DIABLO CANYON UNIT 1
INDEPENDENT DESIGN VERIFICATION PROGRAM
-HVAC COMPONENTS-
ITR #31 REVISION 1 .

Docket No. 50-275
License No. DPR-76

HVAC COMPONENTS

Figure 3 .
 Volume Damper 7A
 Actuator Mounting Plate Welds

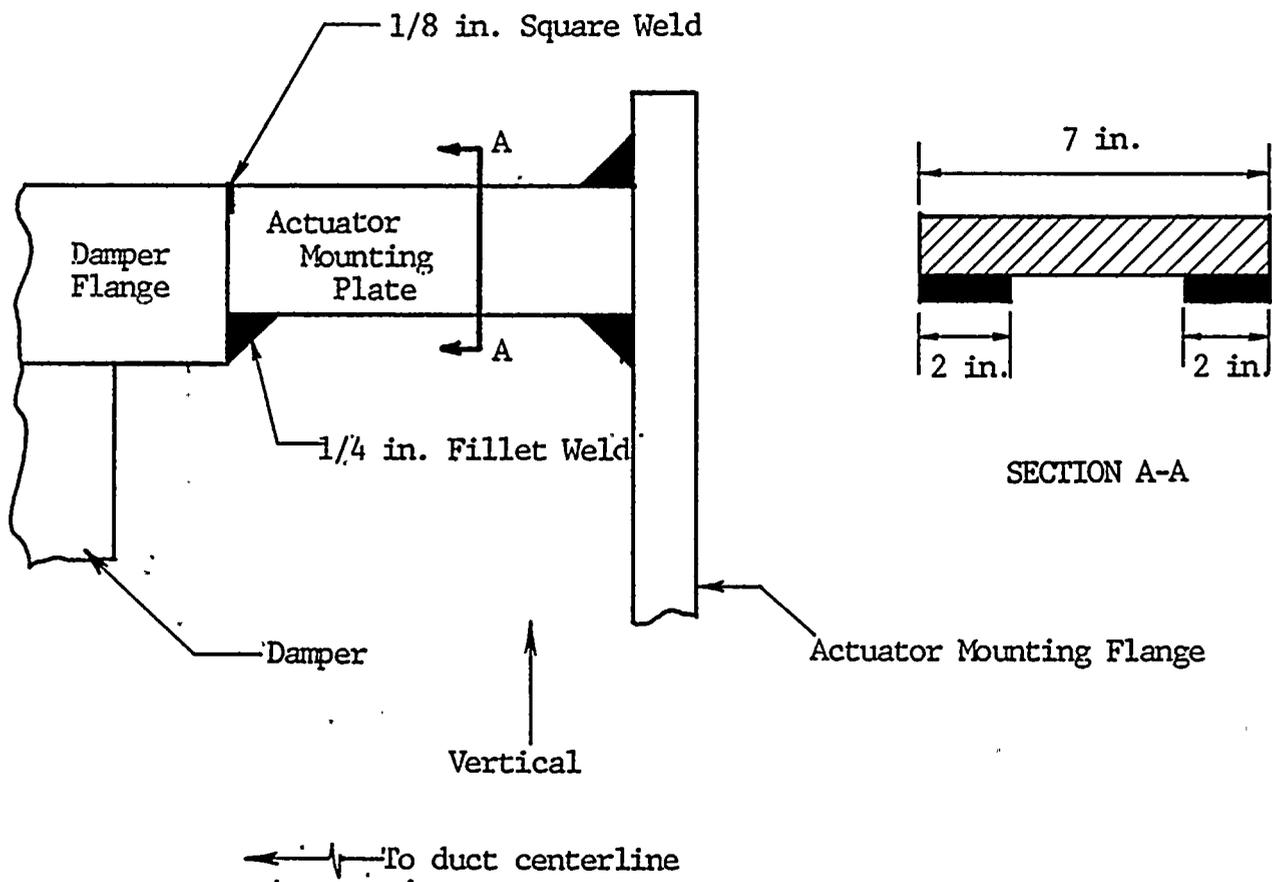
EOI 1083 was issued because the as-built configuration of the damper did not match that shown on the manufacturer's drawing (Reference 9). The drawing showed a square weld and the initial field verification showed two fillet welds. The IDVP modeled the damper based on the initial field verification. The results showed that verification actuator bracket weld stress in the IDVP analysis exceeded the allowable.

When protruding gasket material was removed during a subsequent, more detailed, field verification, the square weld was verified. Using this information in the analysis, the weld was found to be adequate. Therefore, EOI 1083 was resolved as a closed item.

Figure 4
Volume Damper 7A
Actuator to Support I-Beam Plate and Bolts

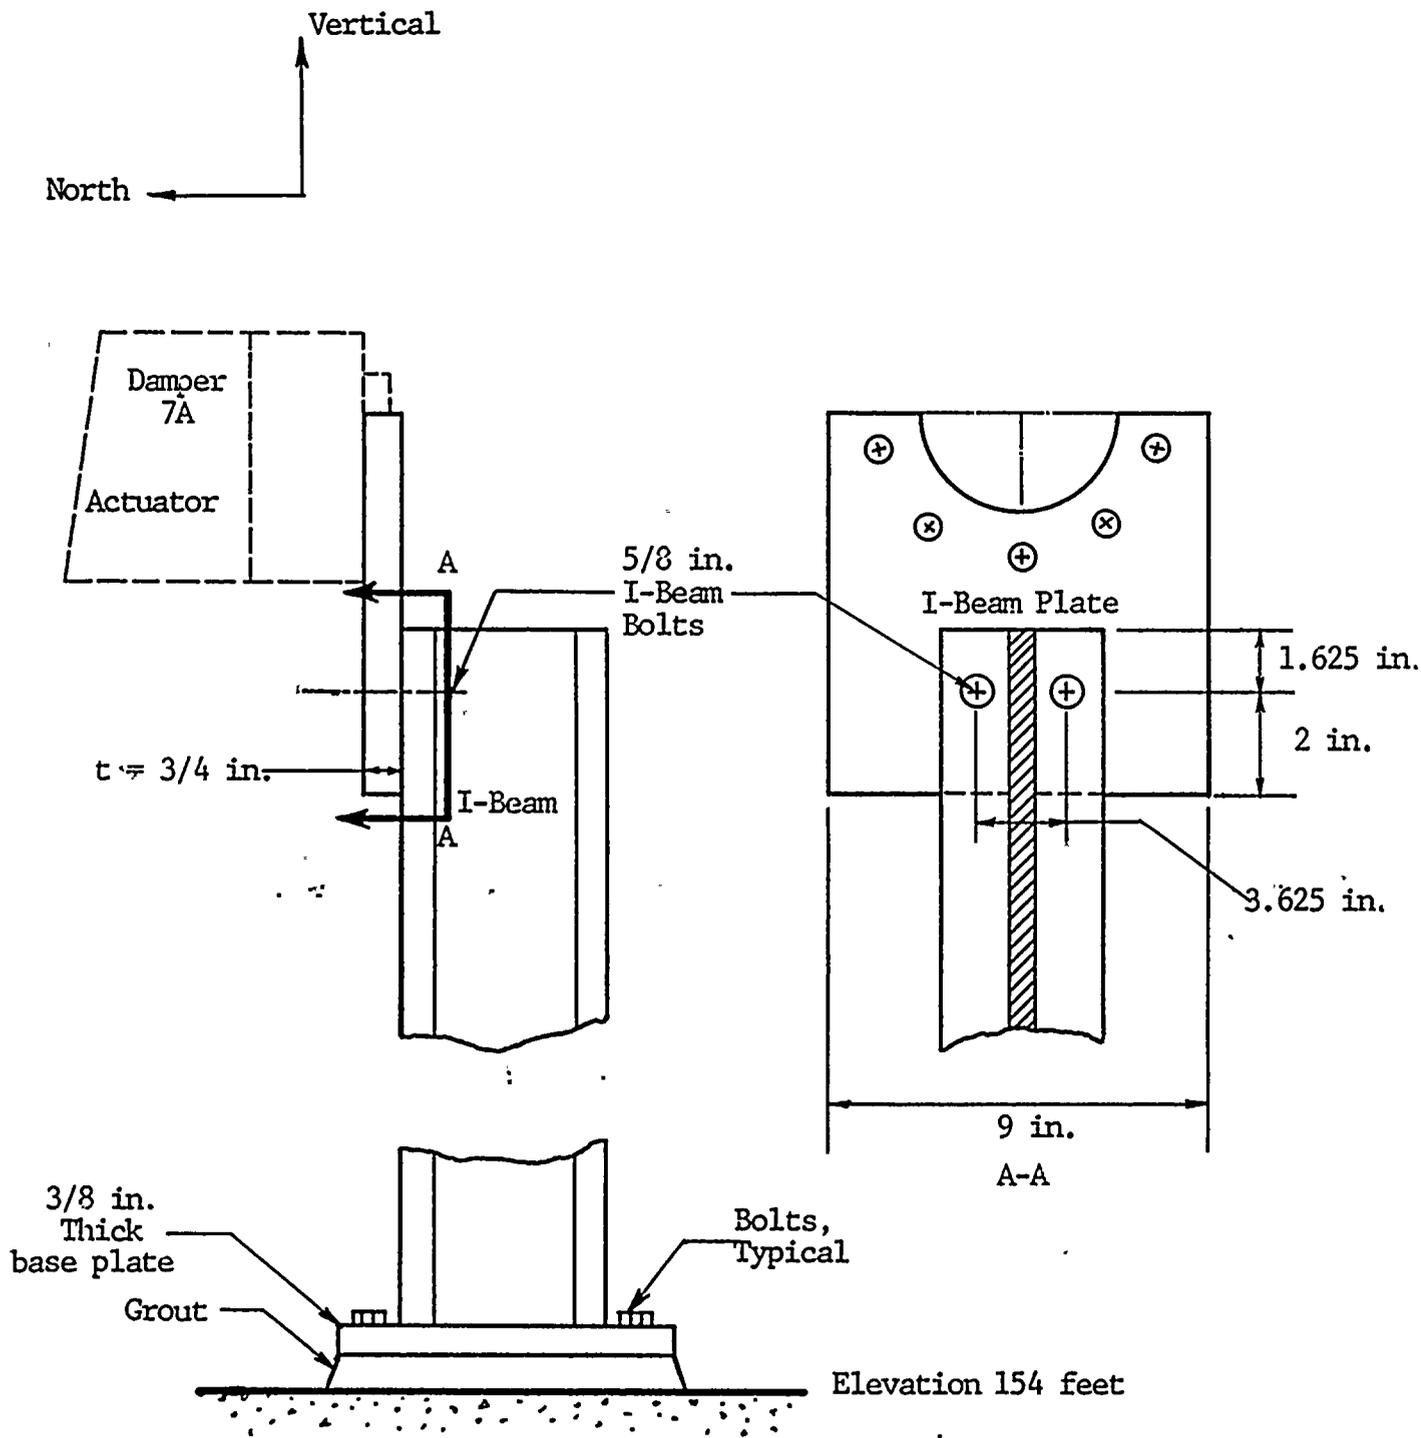
The analyses for the damper actuator supports used the ducting loads as calculated from the duct analysis described above. The effect of the actuator eccentricity with respect to the damper was included in calculating the support loads. This analysis used an incorrect location for the actuator center of gravity (see Section 3.1.6, EOI 1102).

EOI 1102 was issued for the following reasons. First, the manufacturer's analysis of volume damper 7A specified an incorrect vertical acceleration (Reference 6). Second, the flange thickness field verified by the IDVP was different from that specified in the manufacturer drawing. Third, the qualification analyses of the damper, supports and attached ducting did not consider the damper in the as-installed configuration.

For the as-installed configuration of the damper, the IDVP determined after a detailed review of the existing analyses that this was significant only in the analysis of the actuator supports. The analysis of the damper actuator supports considered the actuator center of gravity as 7 inches below and 5 inches to the right of the actuator shaft centerline, whereas the manufacturer showed the center of gravity as 2.1 inches to the right and 8 inches above the shaft centerline (Reference 8).

In conclusion, the vertical acceleration difference and flange thickness difference were determined to be insignificant. On the basis of the center of gravity error for the actuator, EOI 1102 was resolved as a Class C error.

Figure 6

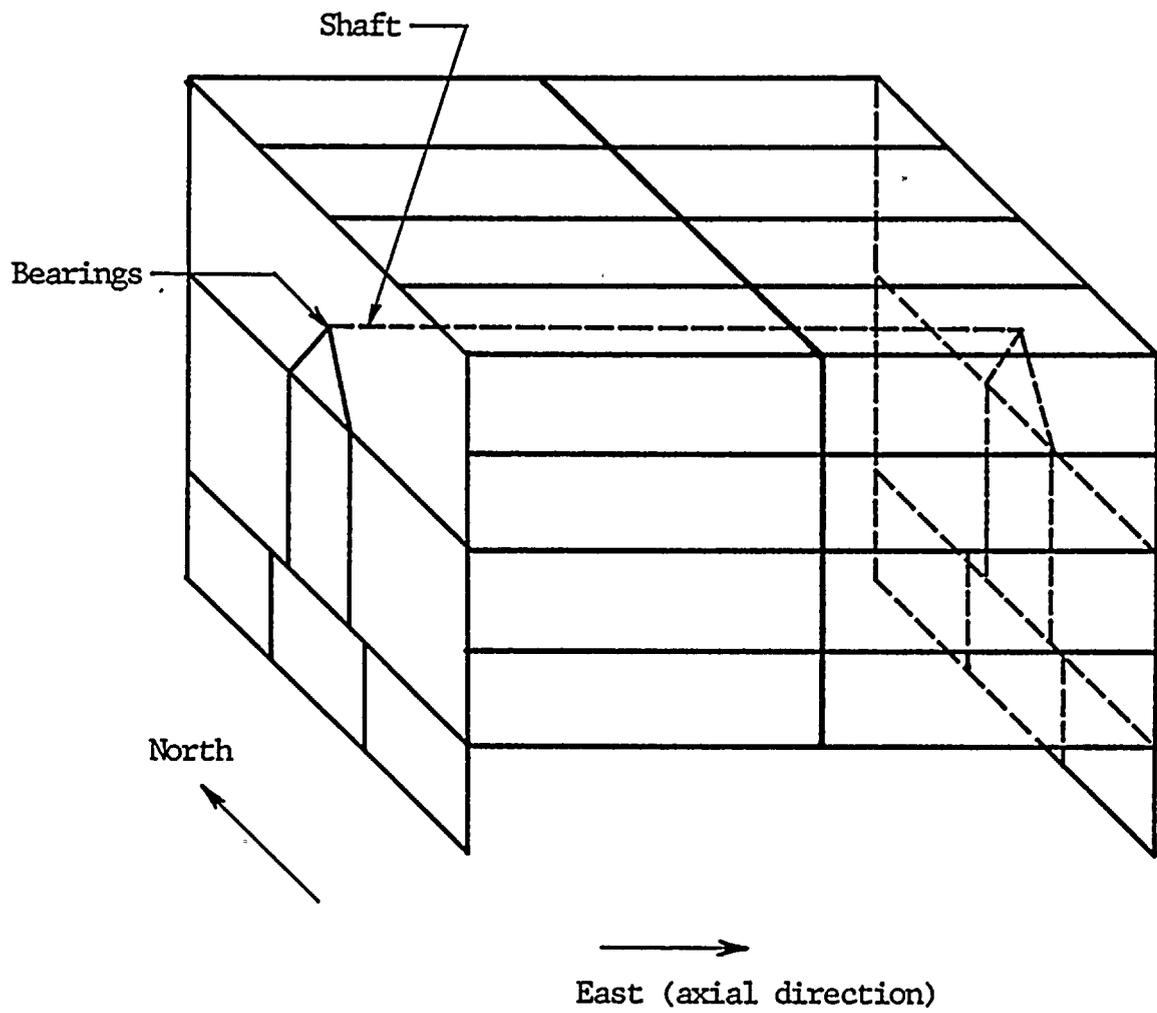
The design analysis calculated the first natural frequency to be 18.8 hertz, assuming that the two bearings share the axial shaft load. The IDVP analysis calculated the first natural frequency to be 16.1 hertz with the same first mode shape, assuming one thrust bearing to resist all axial loads.

The design analysis boundary conditions unrealistically restrained lateral motion of the fan and supports model so that the second natural frequency was calculated to be 33.0 hertz. The IDVP analysis determined that intermediate system natural frequencies existed at 24.6, 29.5, and 29.7 hertz. Substantial modal weight participation occurred for the modes at natural frequencies of 24.6 and 29.5 hertz.

Figure 7

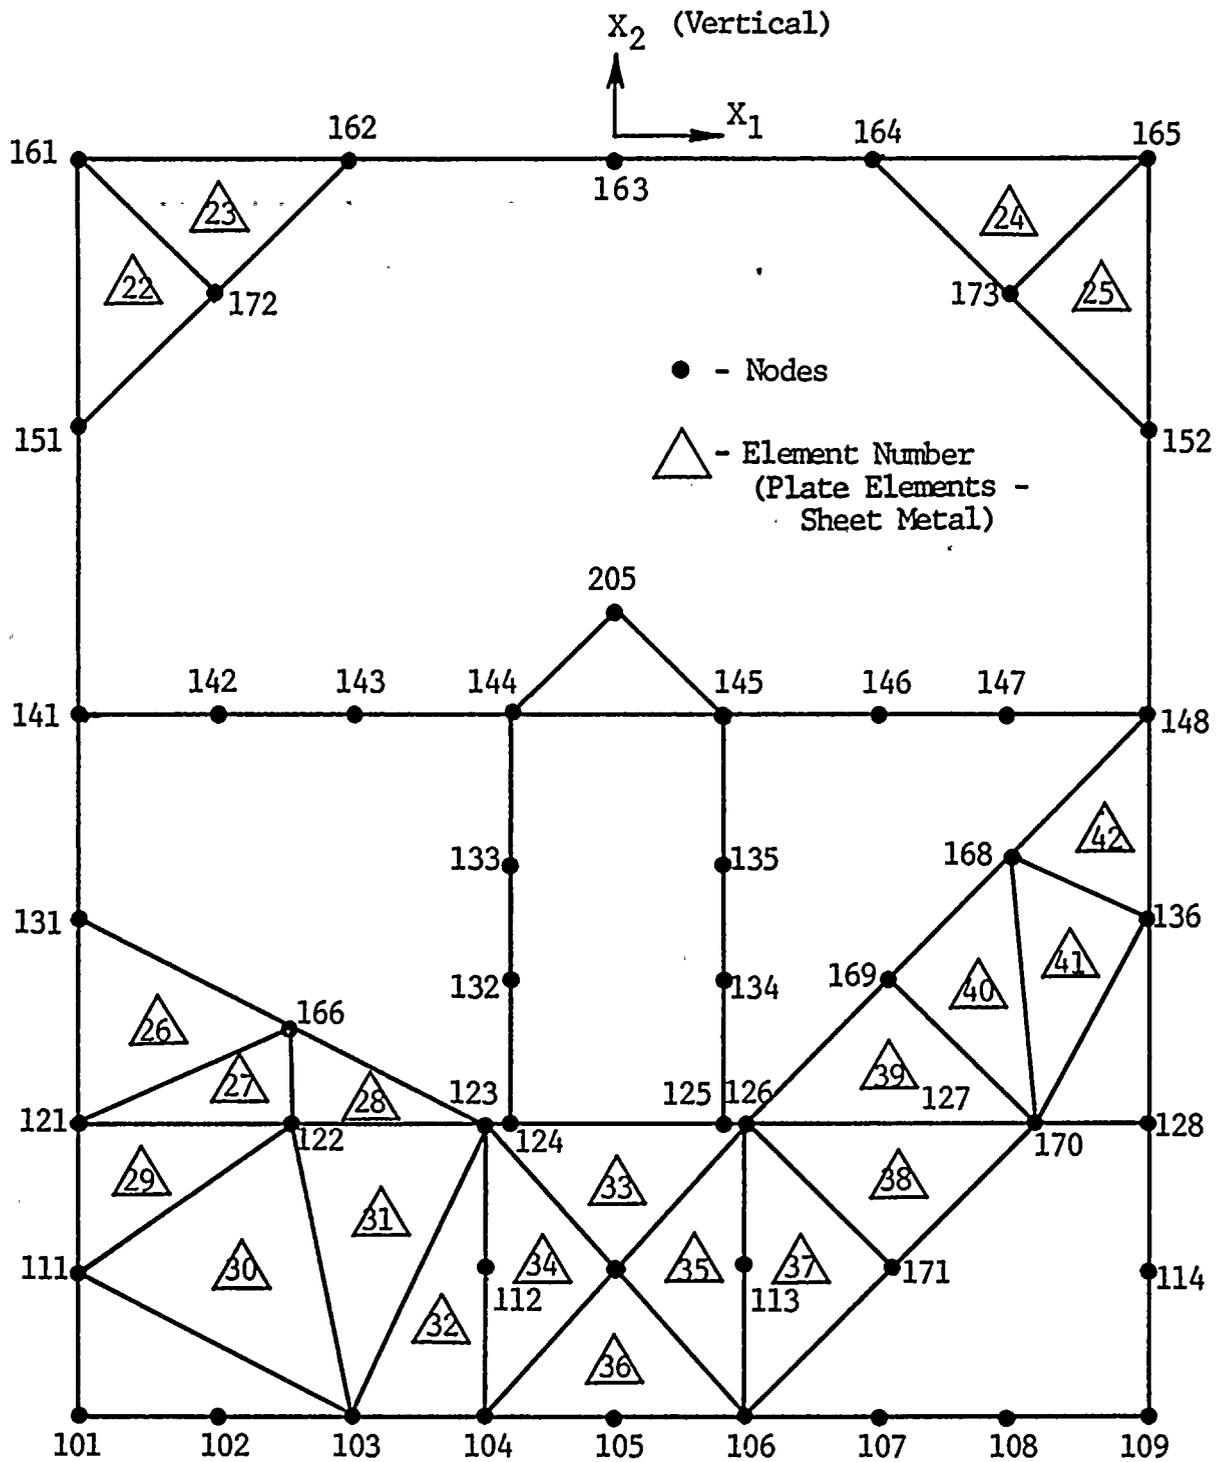
The IDVP refined this analysis to include the stiffness contribution of the sheet metal to the support frames. Portions of the sheet metal were included in the computer model to represent the support frames. One part of the computer model representing the frame is shown in Figure 7.

This refined model more accurately distributed the fan mass. In addition, the support condition of the base angle in the deadweight model was more accurately represented.
